MONTGOMERY COUNTY HISTORIC PRESERVATION COMMISSION
STAFF REPORT

Address:	12 E. Lenox St., Chevy Chase	Meeting Date:	9/7/2022
Resource:	Contributing Resource Chevy Chase Village Historic District	Report Date:	8/31/2022
Applicant:	Justin and Elizabeth Bausch	Public Notice:	8/24/2022
Review:	HAWP	Staff:	Dan Bruechert
Case Number:	1004042	Tax Credit:	n/a
Proposal:	Fenestration Alteration

PROPOSAL

EXT.
ELEVS.

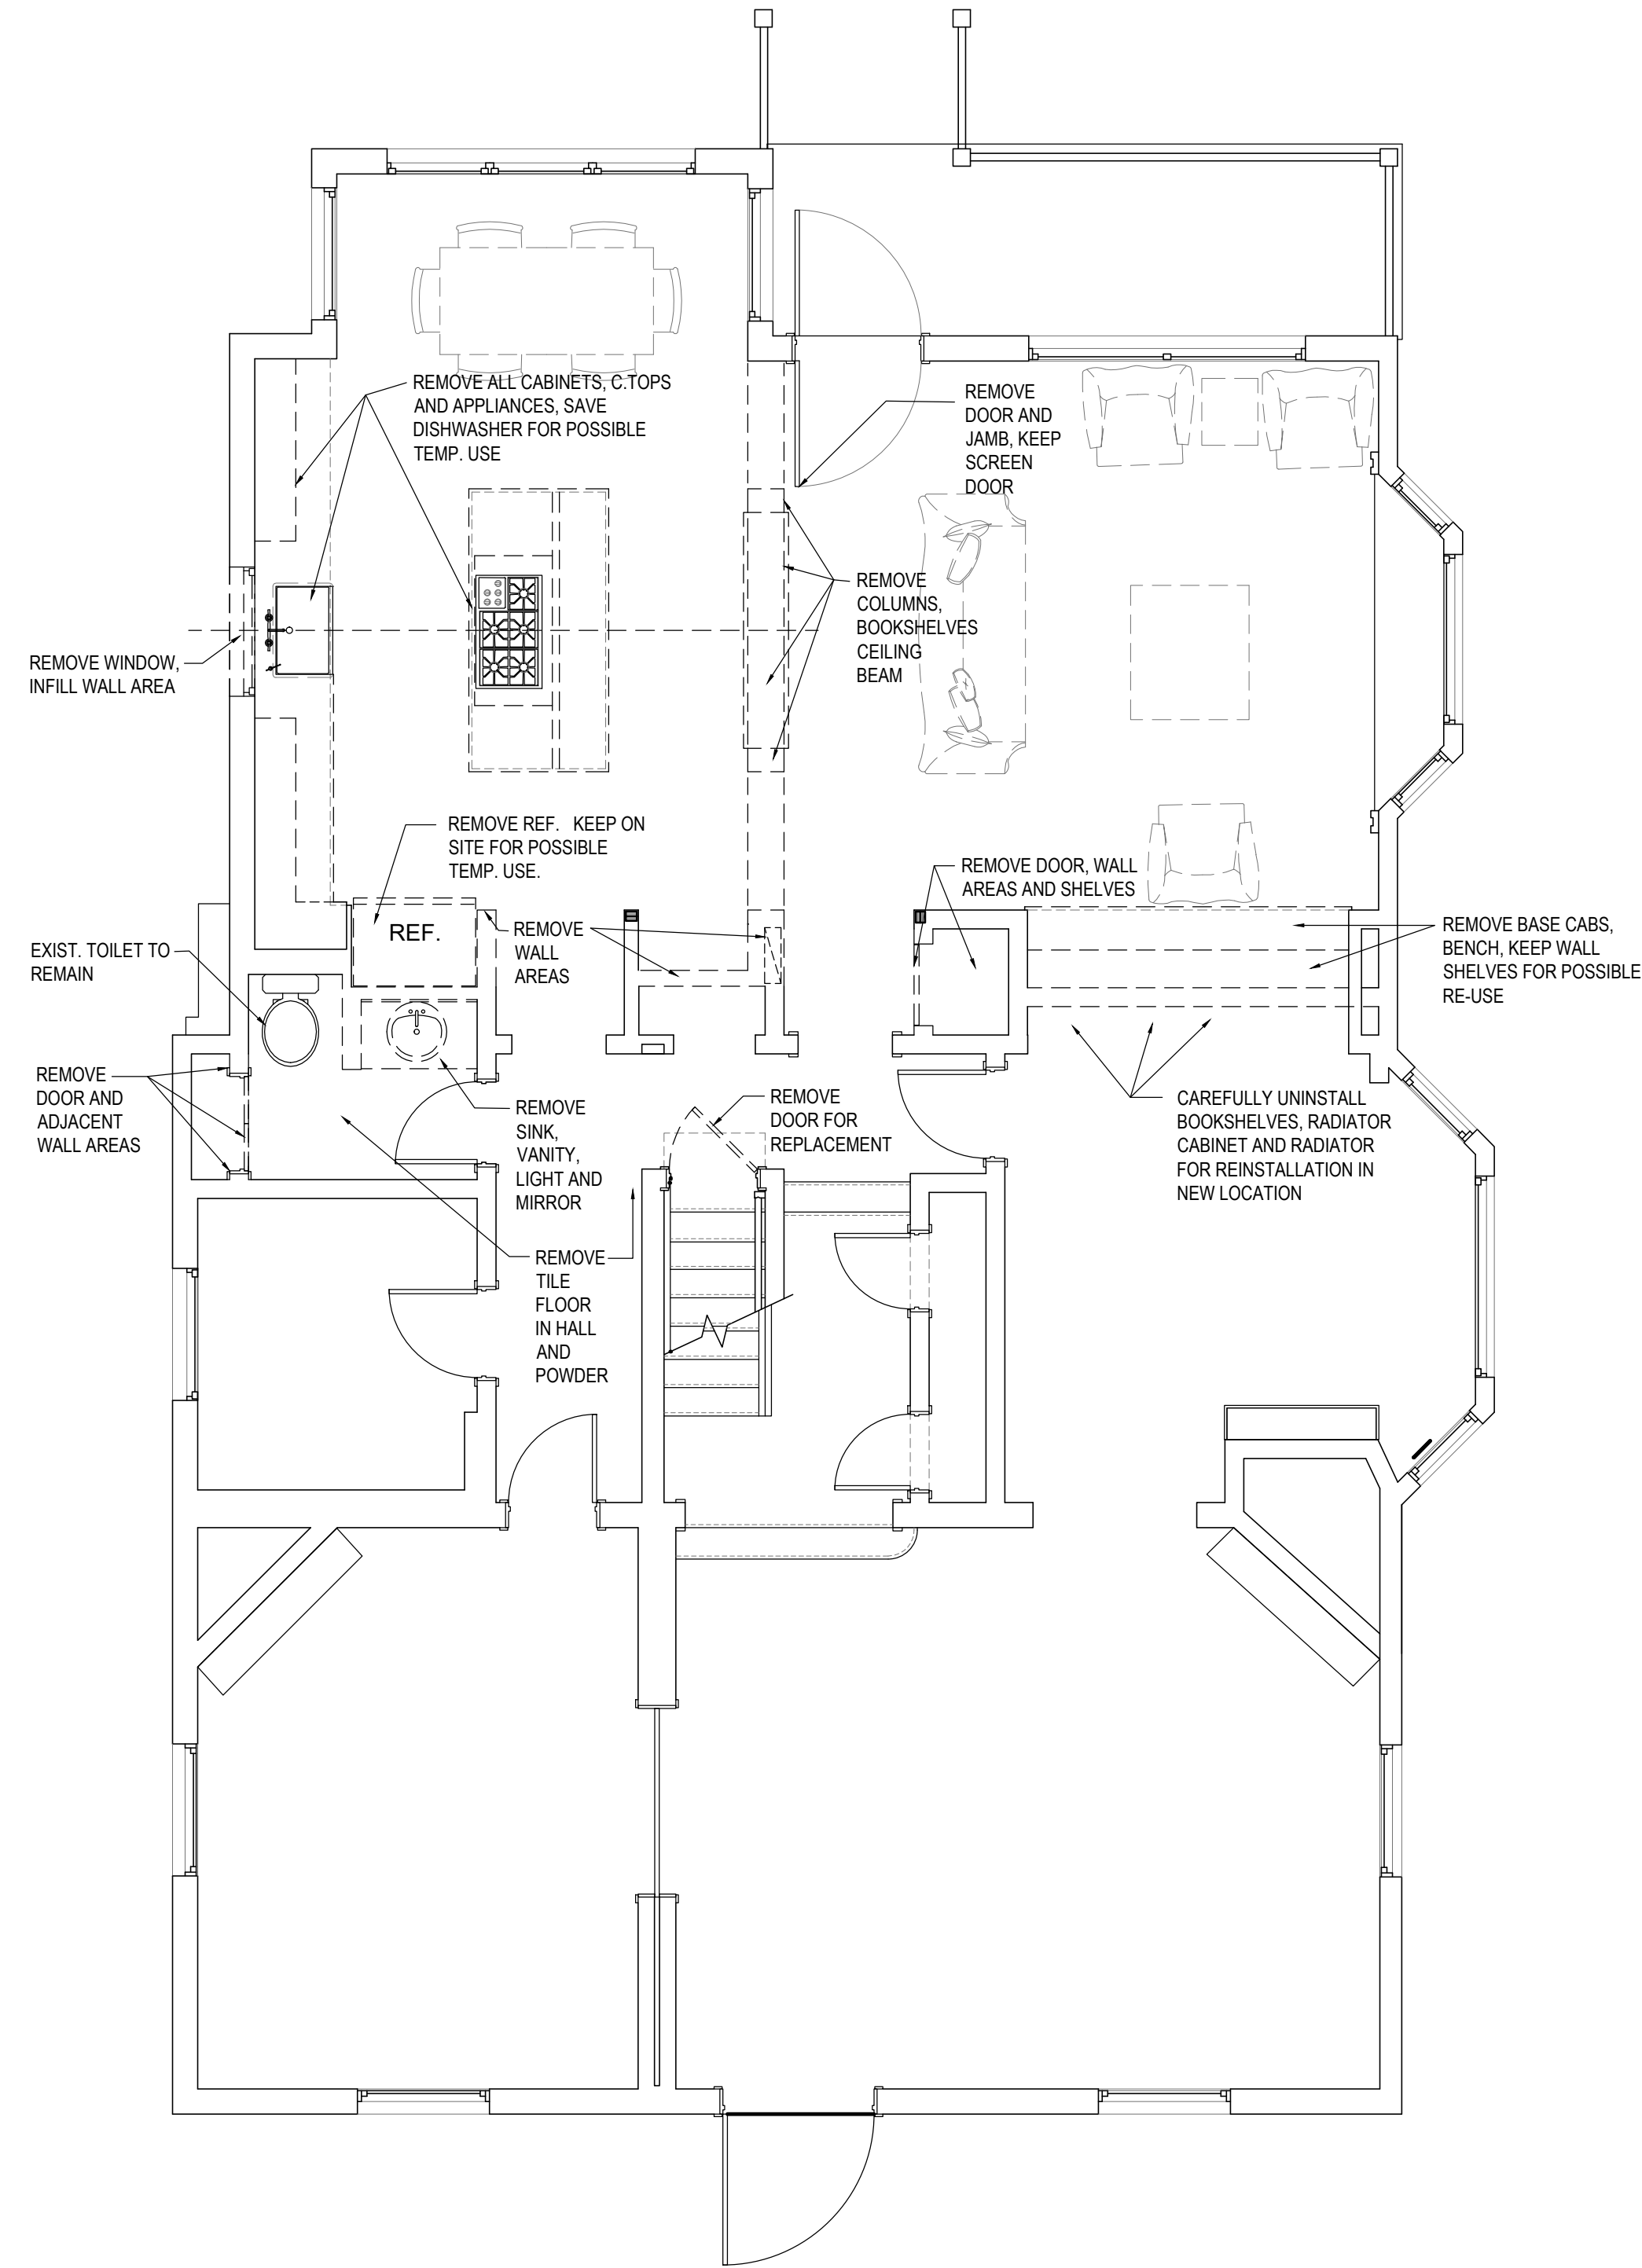
The applicant proposes to make a modest modification to the east by removing one window from the c.2001 addition¹ and installing two casement windows. Before the c.2001 addition, the rear kitchen had

two sash windows (see below). The proposed casement windows have a thicker horizontal bar in the middle with a four-lite pattern in the upper half, resulting in an appearance consistent with a four-over-one sash window.

Staff finds the proposed window configuration will not have a substantial impact on the character of the house or the surrounding district. Additionally, Staff finds a two-window configuration may be more consistent with the historic appearance than the single large sash window. Because the side of the house faces Brookeville Rd. the new windows will be visible from the right-of-way; however, Staff does not find the change will have a substantial impact on the character of the house and recommends the HPC approve the HAWP under 24A-8(b)(2) and (d) and the *Chevy Chase Village Guidelines*.

Staff recommends that the Commission **approve** the HAWP application under the Criteria for Issuance in Chapter 24A-8(b)(2) and (d), having found that the proposal, as modified by the condition, is consistent with the *Chevy Chase Village Historic District Design Guidelines* identified above, and therefore will not substantially alter the exterior features of the historic resource and is compatible in character with the district and the purposes of Chapter 24A;
